# CITY OF ALBUQUERQUE

**RE: 3526 Girard Blvd. NE**  
**Grading & Drainage Plan**  
**Engineer's Stamp Date: 6/19/25**  
**Hydrology File: G16D160**  
**Case # HYDR-2025-00221**

ENGINEER'S SEAL  6/19/25 DAVID SOULE P.E. #14522	LOT 2 CHARLES D. MALCOLM ADDITION 3526 GIRARD BLVD NE  GRADING AND DRAINAGE PLAN   Rio Grande Engineering P.O. BOX 53924 ALBUQUERQUE, NM 87199 (505) 321-9099	DRAWN BY DEM DATE 6-18-25 C:\SSS\Girard Blvd NE - 3526.dwg
		SHEET # C1 JOB #

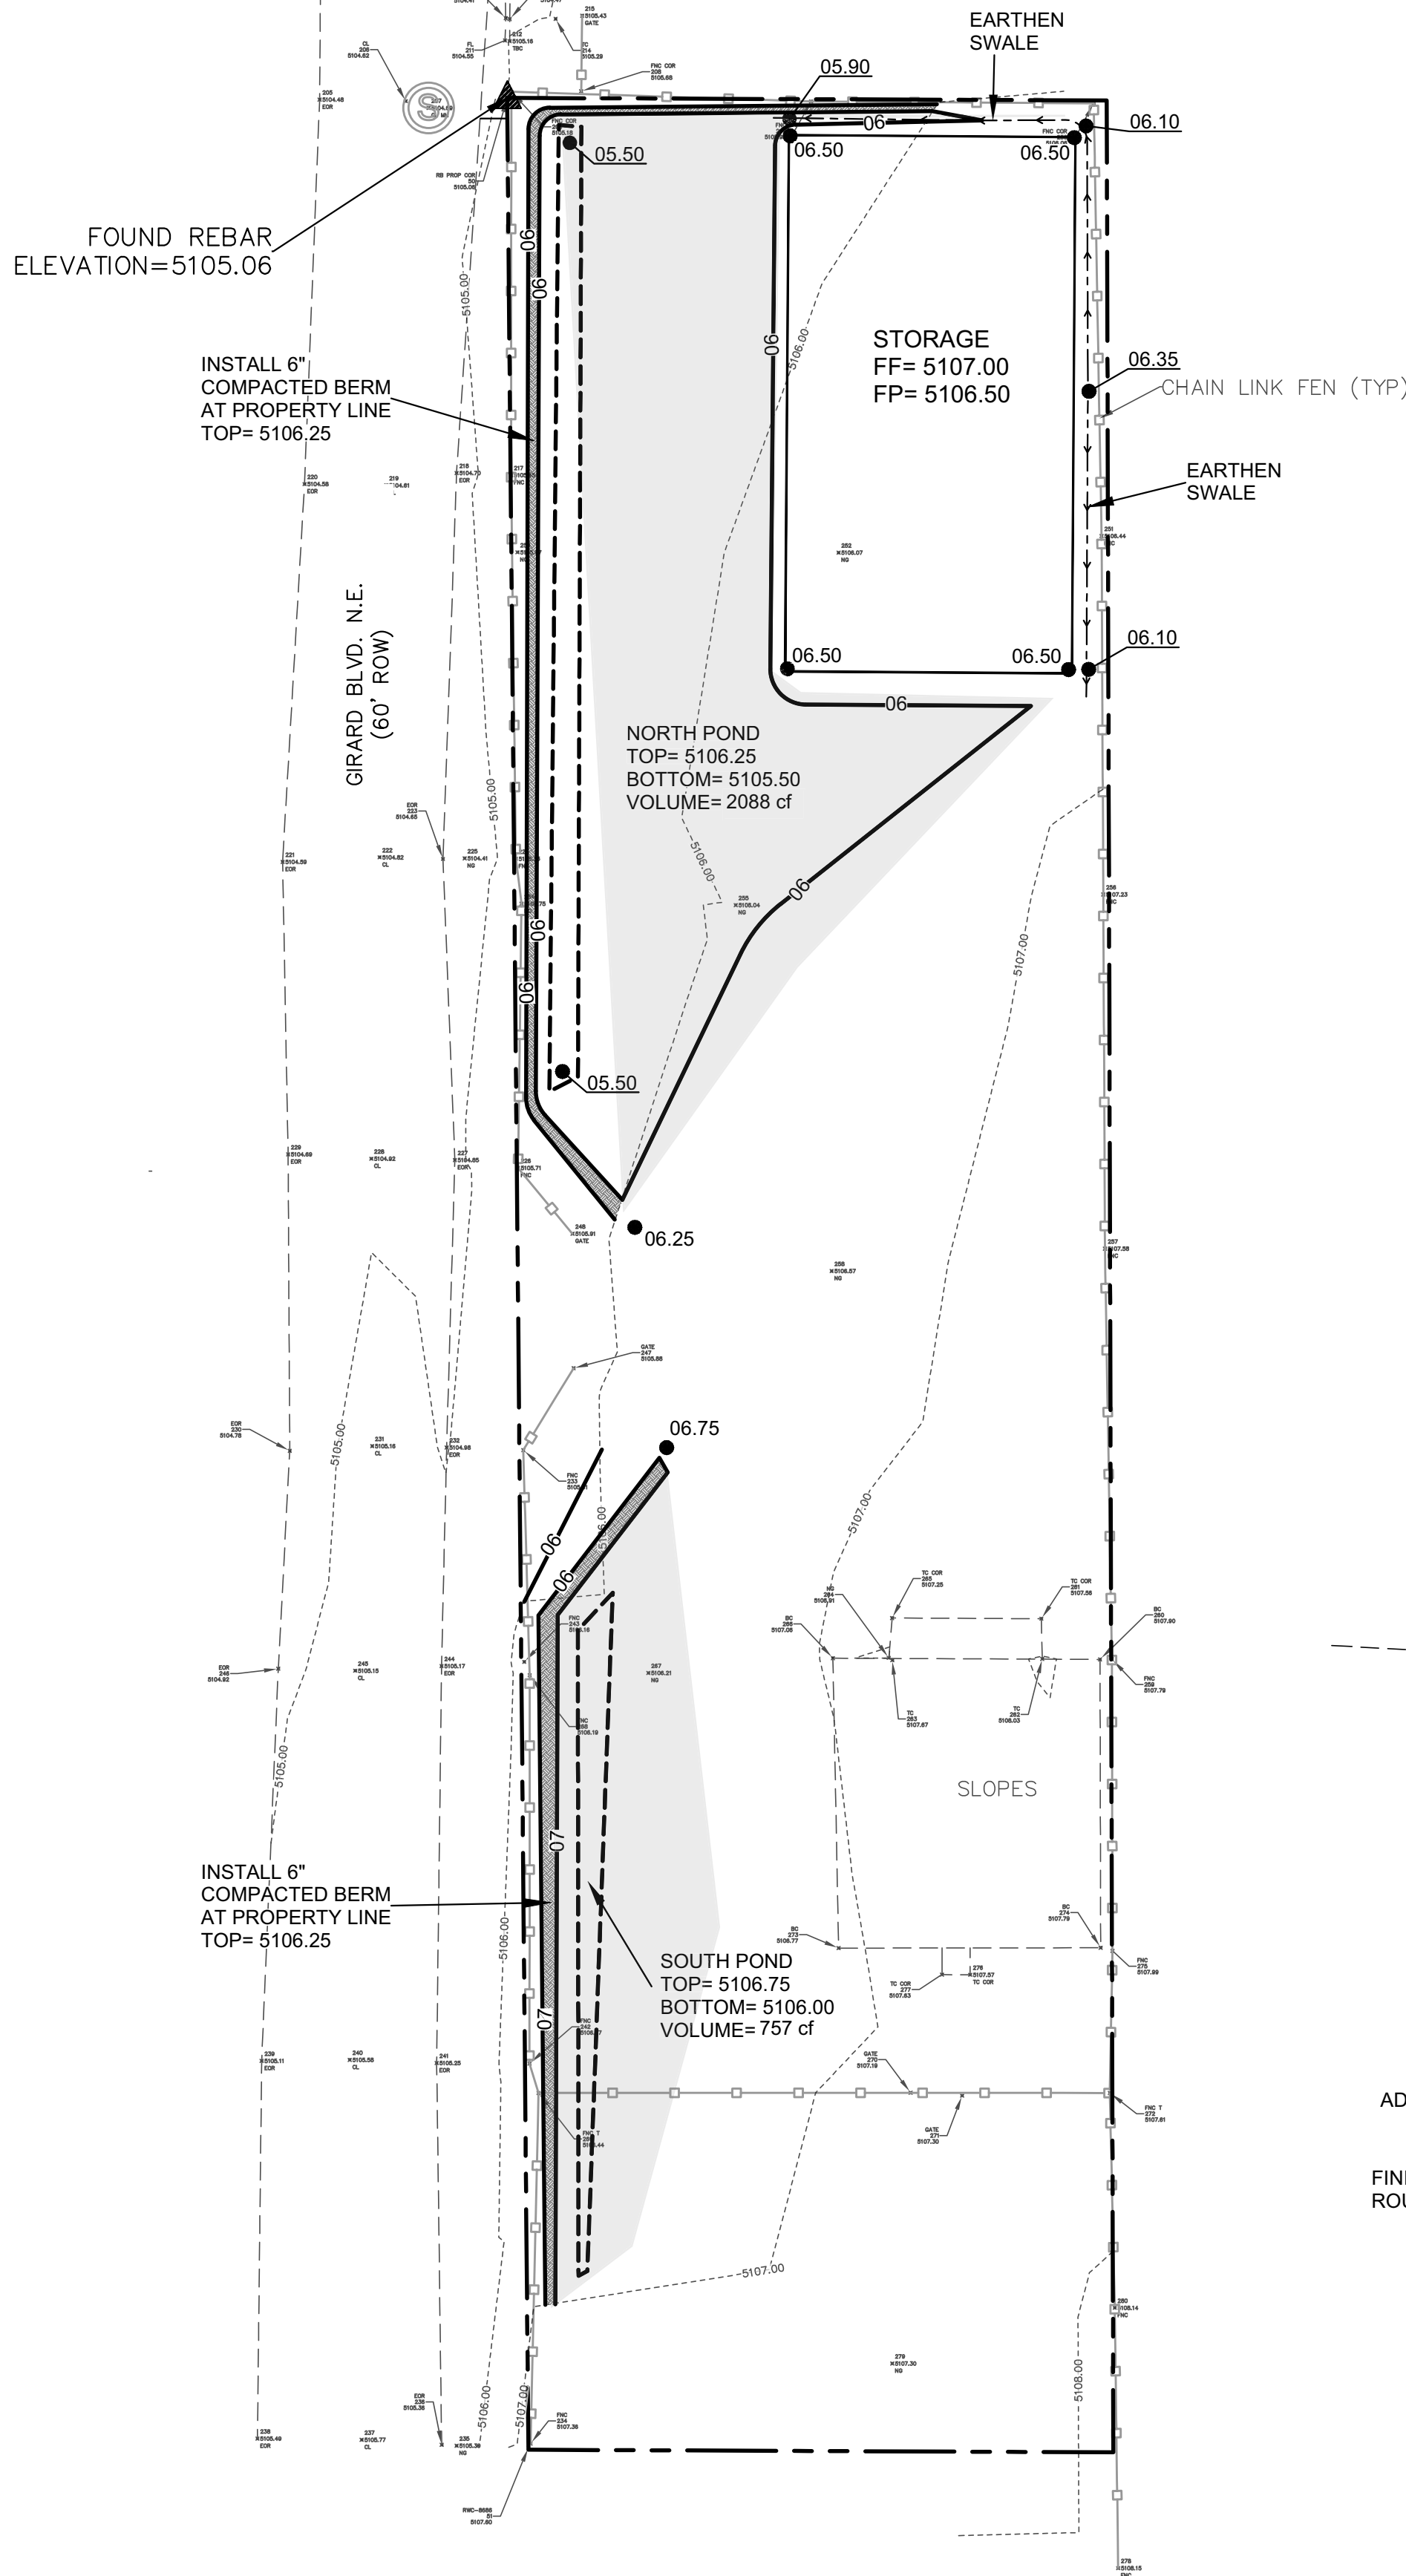
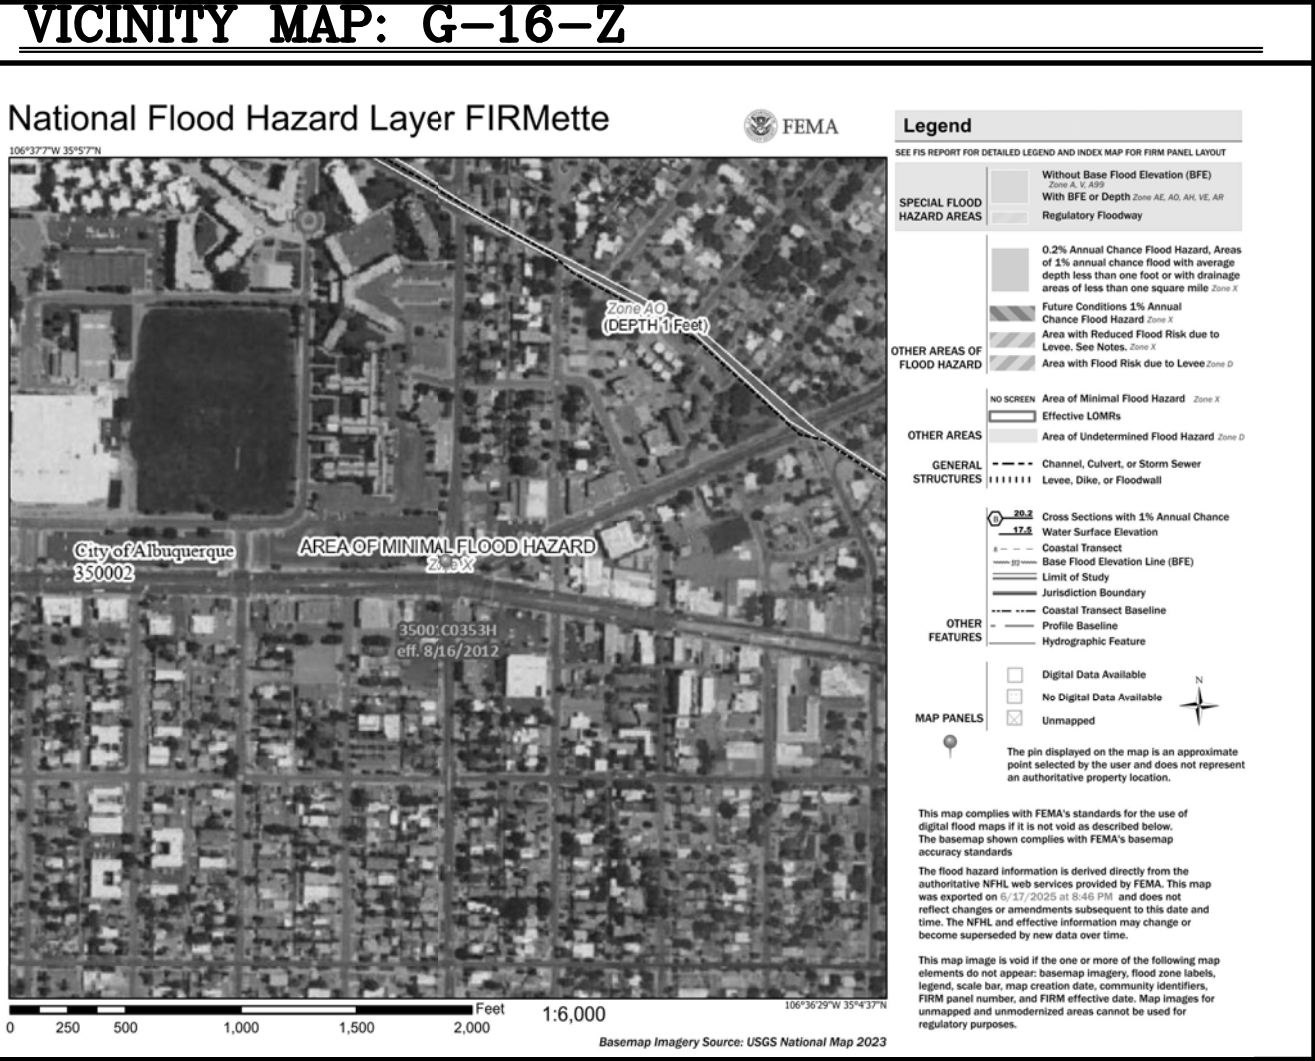
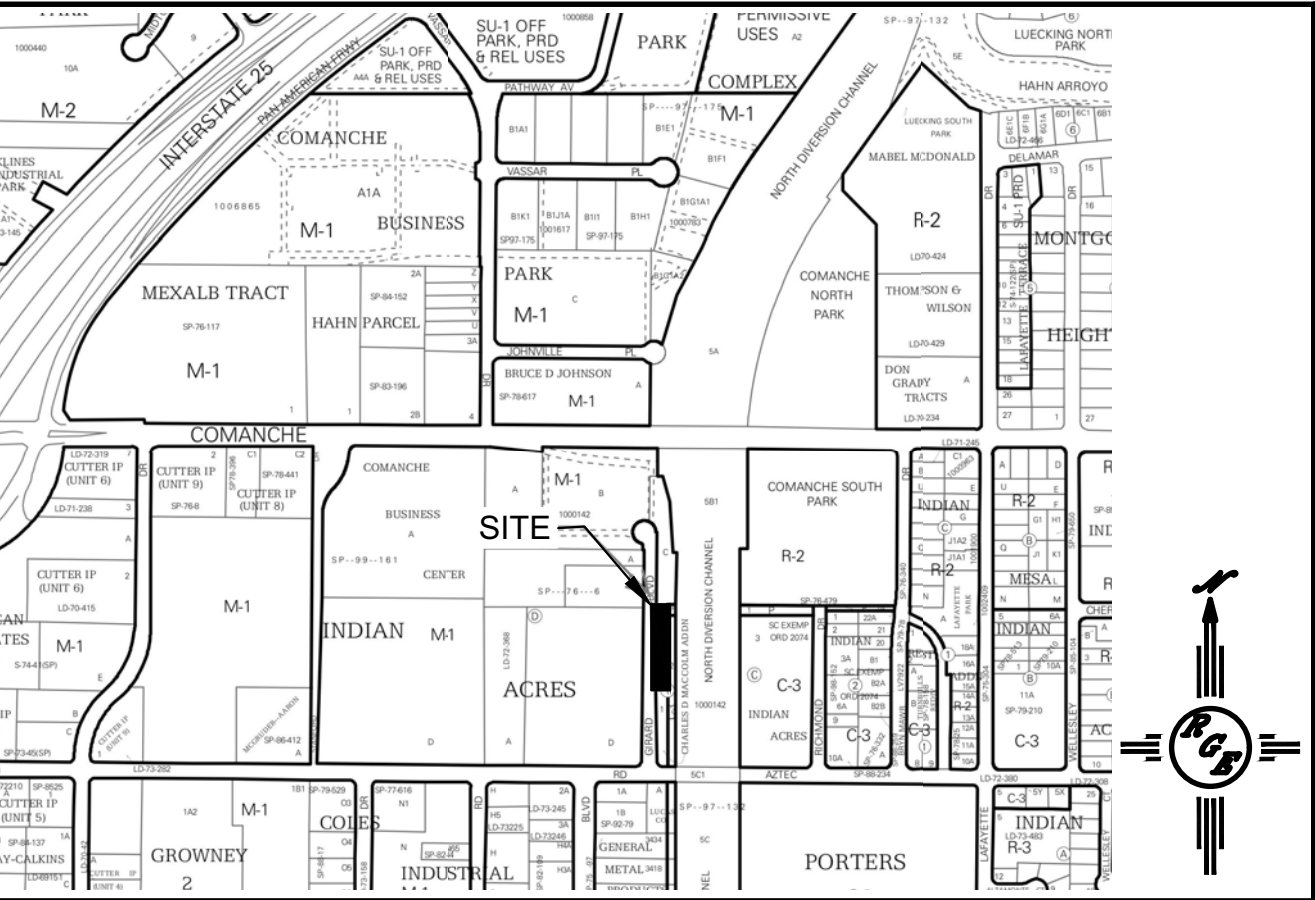
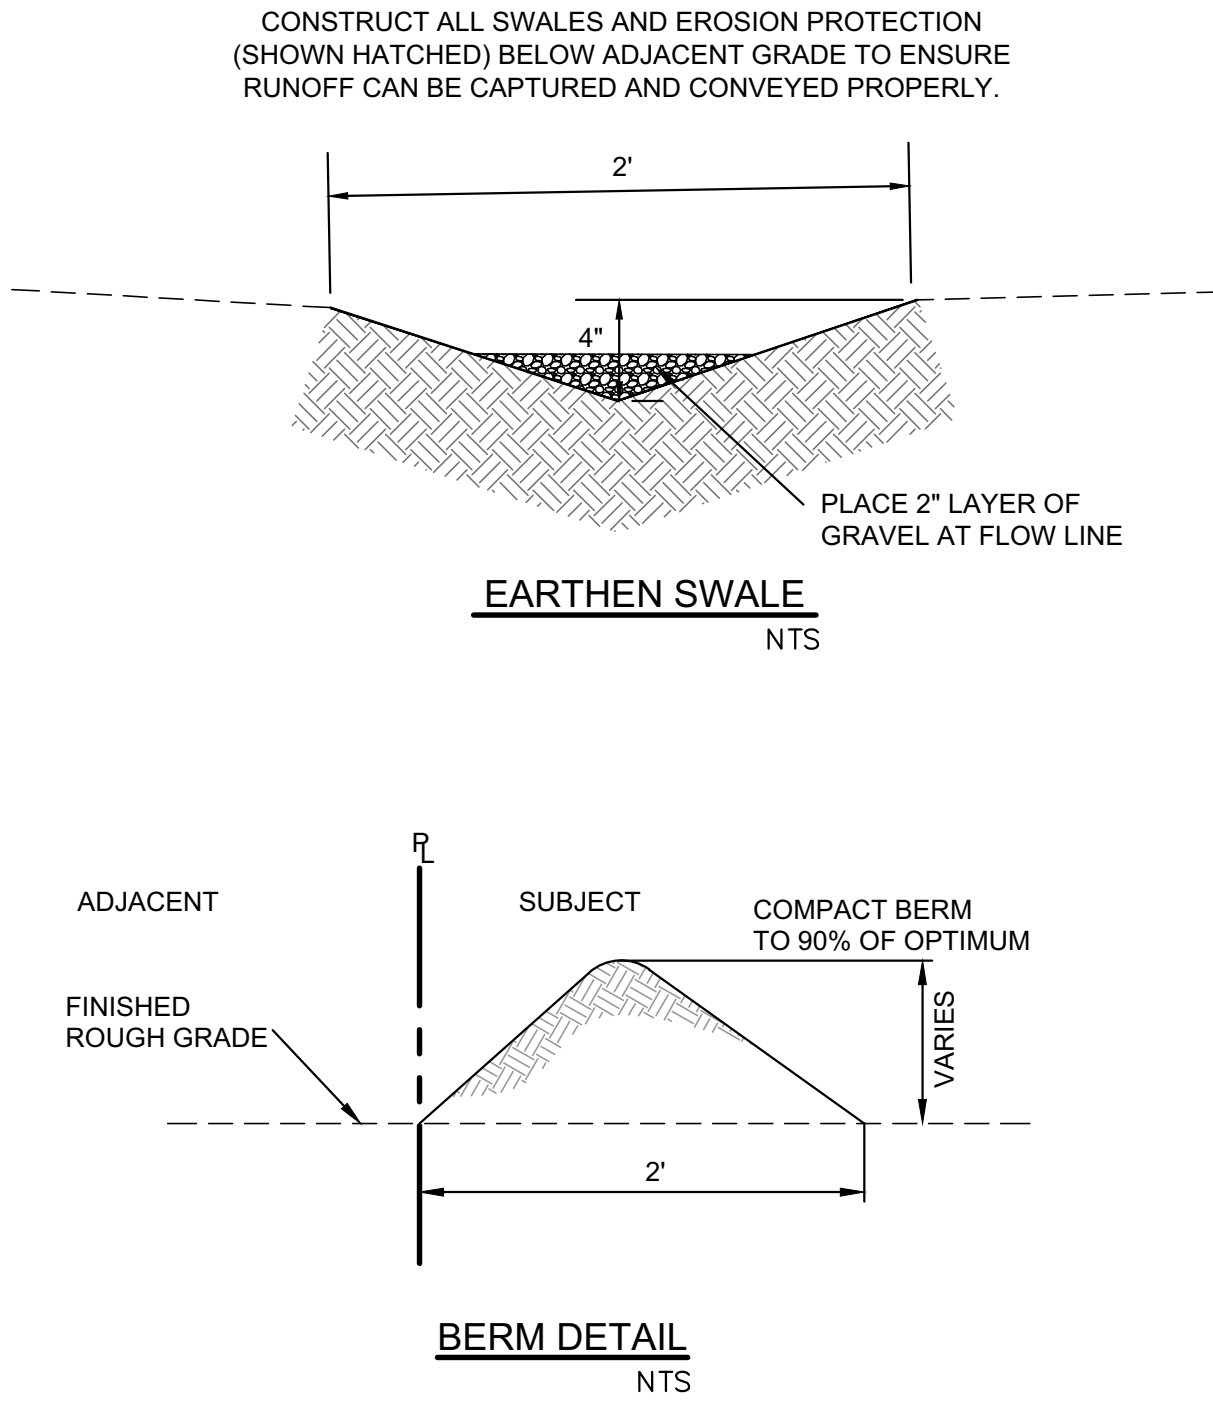
Based upon the information provided in your submittal received 6/19/2025, the Grading plan is **approved** for Grading Permit and Building Permit. Please attach a copy of this approved plan in the construction sets for Building Permit processing along with a copy of this letter.

1. Engineer's Certification, per the DPM Part 6-14 (F): *Engineer's Certification Checklist For Non-Subdivision* is required.
2. Please provide the executed paper Drainage Covenant (latest revision) printed on one-side only with Exhibit A and a check for **\$25.00** made out to "**Bernalillo County**" for the detention ponds per Article 6-15(C) of the DPM to Hydrology for review at Plaza de Sol.
